MEMORANDUM

DATE May 23, 2025 PROJECT 24349
NUMBER
TO Cherylle Goebel PROJECT 302 Loreto Street, Mountain View
Andreas Goebel
OF 302 Loreto Street FROM Walker Shores, Architectural Historian
Mountain View, CA 94301 Cultural Resources Planner
Stacy Kozakavich, Cultural Resources
Planner, Project Manger
CC Christina Dikas, Principal-in-Charge VIA Email

REGARDING 302 Loreto Street, Mountain View – *Secretary of the Interior's Standards for Rehabilitation Analysis*

Figure 10. Proposed site plan. Rear addition is indicated by hatching. Source: "Single Family House", by Better Built Builders, (February 2, 2025), Sheet A-1.

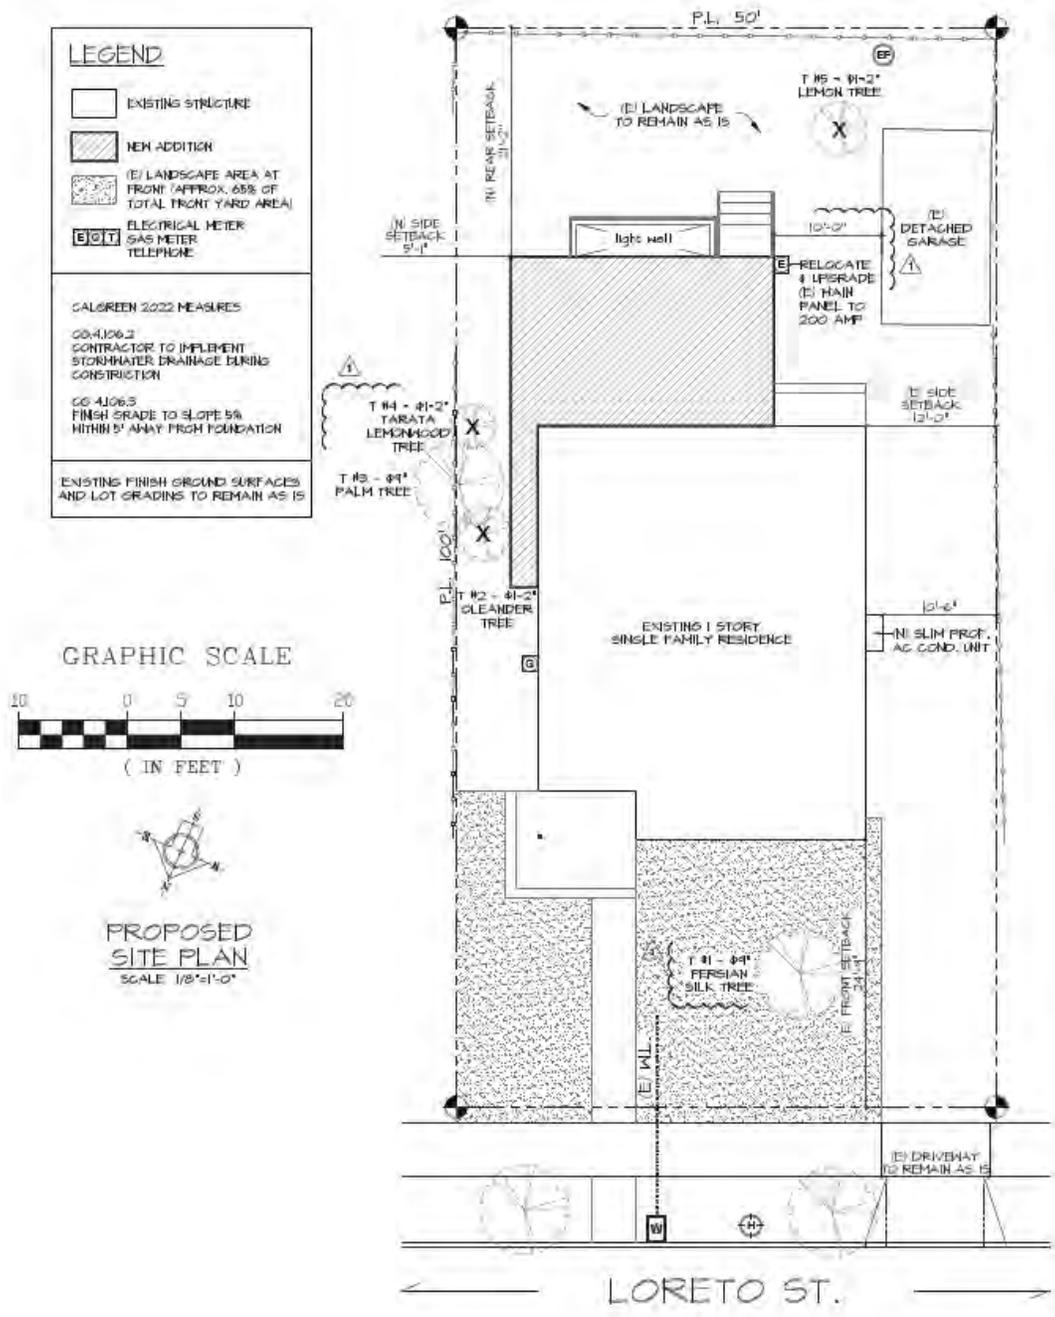
- One-story over basement, 415 square-foot addition at the northwest corner of the building. The addition would project from the north end of the west façade by two and a half feet, and the roof line of the addition would be eleven inches higher than the existing roof line. The addition would include:

The proposed project would construct a one-story over basement, 415-square-foot addition at the northwest corner of the building, projecting from both the north end of the west façade and the west end of the north façade. The addition would be at the rear side of the house and would be minimally visible from the Loreto Street public right-of-way. The new addition would feature a gable roof and be clad in wood lap siding to match the existing residence, but the new windows, sliding door, slightly higher floor plate height, and the slight projection of the west wall from the existing west façade would sufficiently distinguish it as an addition. While the current project proposes the use of vinyl windows at the addition, if the project opts to use metal-clad windows or wood windows with the same operability and lite patterns as those depicted on the drawings, the compatibility and differentiation of the addition would be the same as that analyzed here. The fenestration pattern at the rear of the building would be altered, but the fenestration pattern at the rear of the building is not a character defining feature and the windows' alteration or removal would not diminish the significance of the building. The proposed addition would project two and a half feet from the north end of the west façade, and the roof line would extend eleven inches above the current roof line. These projections are small, and all located at the rear of the building, and would therefore be minimally visible when viewed from the street. Therefore, the location, design, and overall scale and massing of the addition would minimally affect historic material and would not diminish the historic character of the residence while allowing the residence to remain visually prominent. The proposed project would also install a new concrete step and landing at the front porch which is approximately two feet larger to the west and five feet larger to the south of that existing. The porch, step, and landing will remain in the same location at the southwest corner of the building, the expansion of the porch would not alter the spatial relationship of the primary entrance organization. Thus, the proposed project is in compliance with Rehabilitation Standard 9.

Figure 11. Front and Rear elevations, showing the proposed addition, removed brick sidewall, and removed internal chimney. Source: "Single Family House", by Better Built Builders, (February 2, 2025), Sheet A-5.

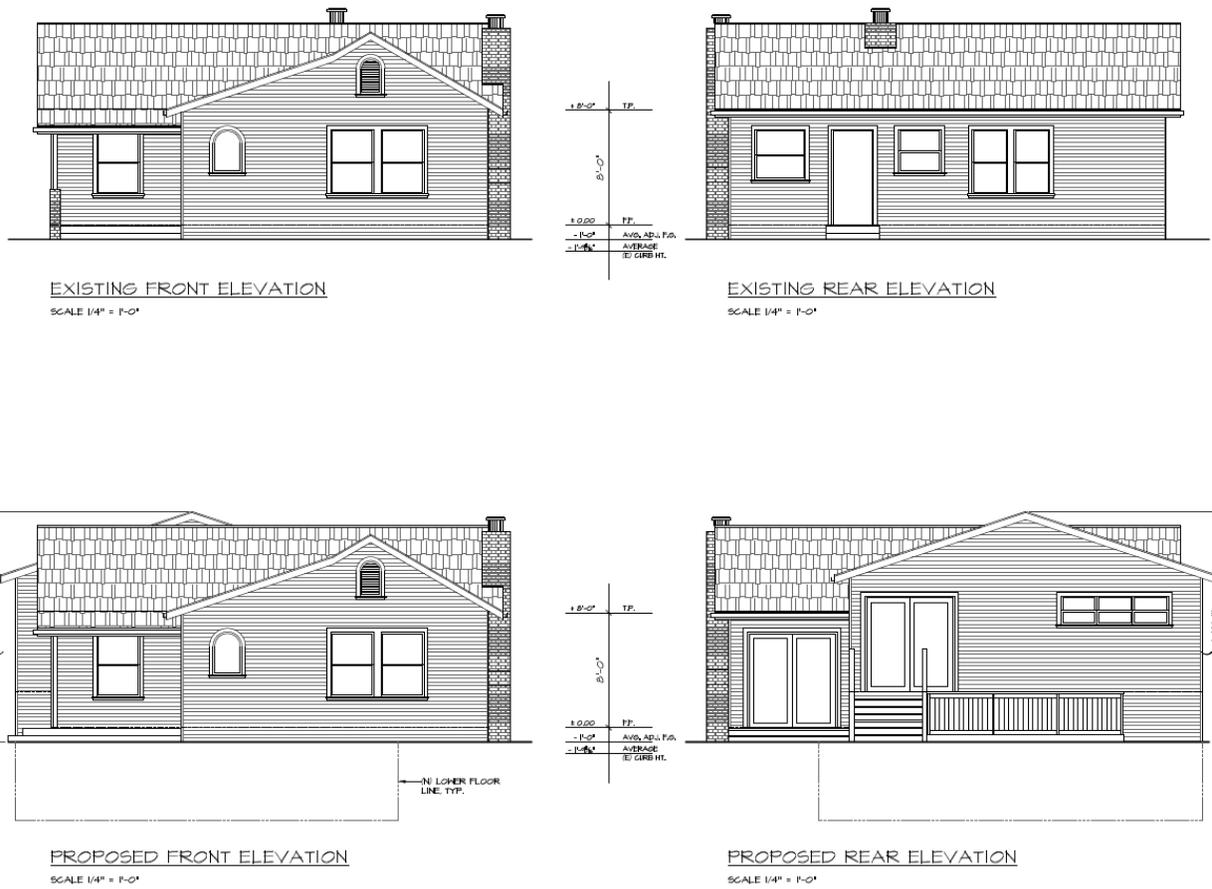
- Gable roof with asphalt shingles to match existing roof
- Remove the internal brick chimney from the north roof slope.
- Remove the non-original brick sidewall at the front porch.

The proposed rear addition would remove one original opening at the north end of the west façade and all openings on the north façade. This also would result in the removal of some original wood lap siding. The features changed by construction of the addition are either minimally visible or not visible from the public right-of-way, and their removal would not impair the ability of the building to convey its significance. The interior chimney at the rear of the house would be demolished, but the interior chimney is minimally visible from the street and not a character defining feature. The brick wall proposed to be removed at the entry porch is not original and therefore not a character defining feature. The expansion in size of the front porch concrete step and landing would utilize the same materials (concrete) at the same plate height, and would therefore not meaningfully impact the spatial relationship of the primary entrance organization of the building. The construction of the proposed addition would not meaningfully impact significant spatial relationships at the site, such as the orientation of the residence to the detached garage, and will not meaningfully impact circulation routes. Thus, the removal of the specified original openings is not likely to affect the historic character of the residence and the proposed project is in compliance with Rehabilitation Standard 2.

Figure 13. East (right) elevations, showing the proposed addition, removed brick sidewall, and removed internal chimney. Source: "Single Family House", by Better Built Builders, (February 2, 2025), Sheet A-7.

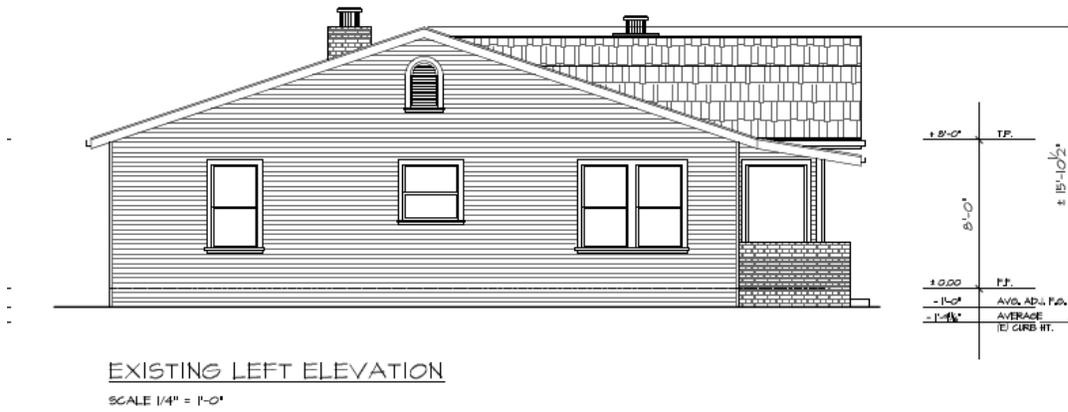
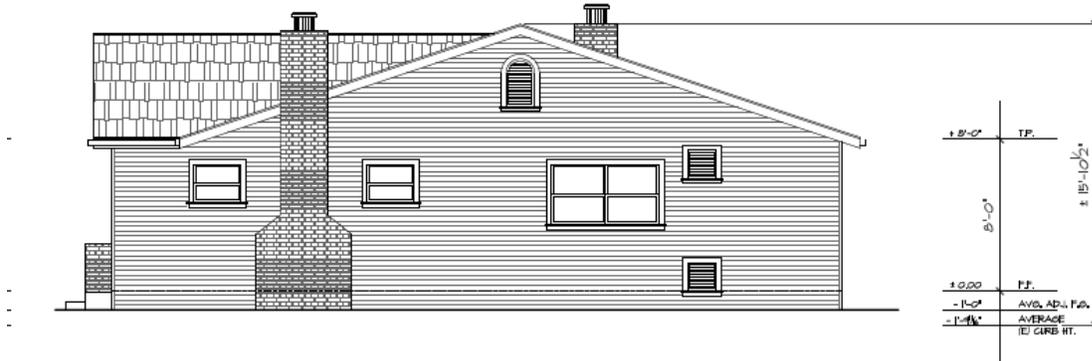
The proposed addition is located at the rear of the residence and if, hypothetically, removed in the future, the general form and integrity of the residence as viewed from the street would be unimpaired. As previously discussed, only non character defining openings and features at the rear
